City of Detroit
Inter-Departmental Communication

RE: Petition No. 349
Requested Encroachment into Cass At 4710 Cass (With Outdoor Seating And
Canopies) In The Area Bound By Hancock, Woodward, Forest, And Cass

PROVISIONS FOR ENCROACHMENT For Petition 349

REQUEST ENCROACHMENT
 INTO CASS
 AT 4710 CASS AVE.
 (With Outdoor Seating and Canopies)

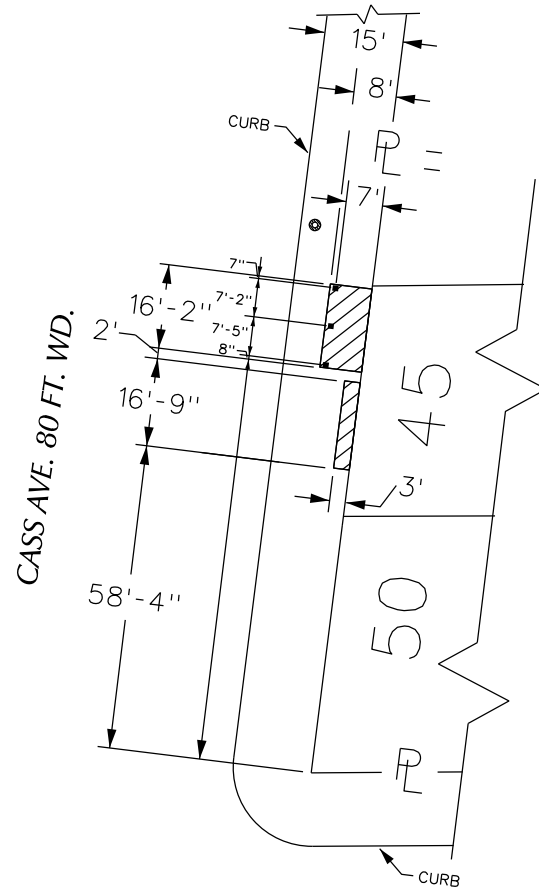
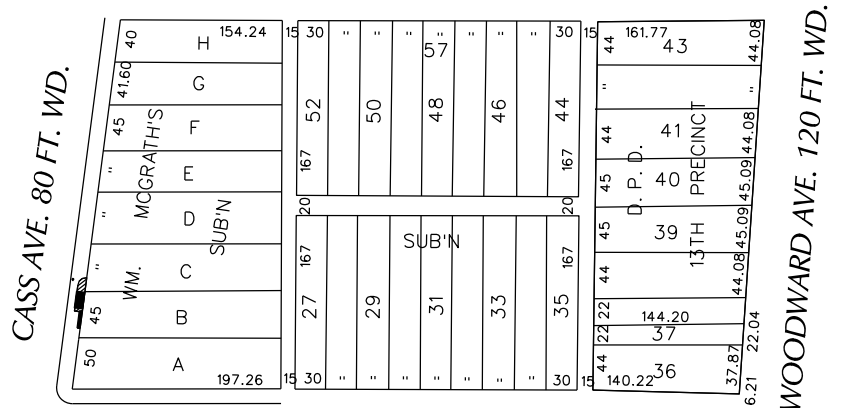
- DWSD has no objections to the requested encroachments provided that the attached Provisions for Encroachment are strictly followed.

2. DWSD requires a vertical clearance of 18 feet above grade for maintenance excess and repair.
3. All construction performed under this petition shall not be commenced until after five (5) days written notice to DWSD. Seventy-two (72) hours notice shall also be provided in accordance with P.A. 53 1974, as amended, utilizing the MISS DIG one call system.
